NUMBER: 23-011-23

Front Floor Center Console Surface Feels Warm

2021 - 2022 (WL) Jeep Grand Cherokee/Grand Cherokee L

Fig. 1
Passenger's Side

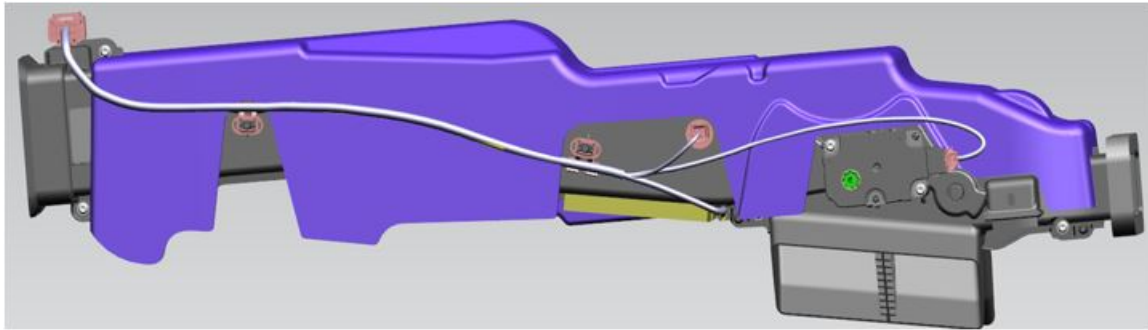
NOTE: When installing the cover make sure not to cover the wire harness on the floor duct. The photos below show the covers already installed (purple in color) (Fig. 1) , (Fig. 2) and (Fig. 3) .

Fig. 5
Retainer Clip Properly Attached

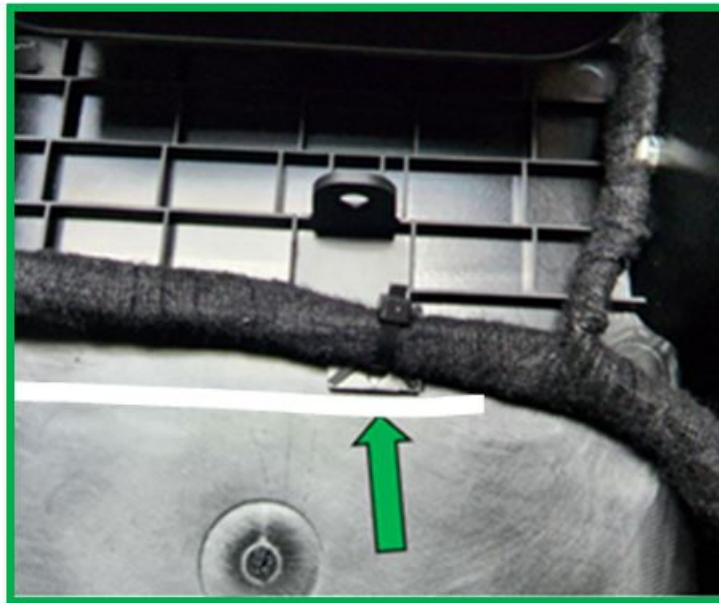
3. If retainer clip is not attached, peel off paper from adhesive and stick retainer clip to the underside of the console (Fig. 5) .
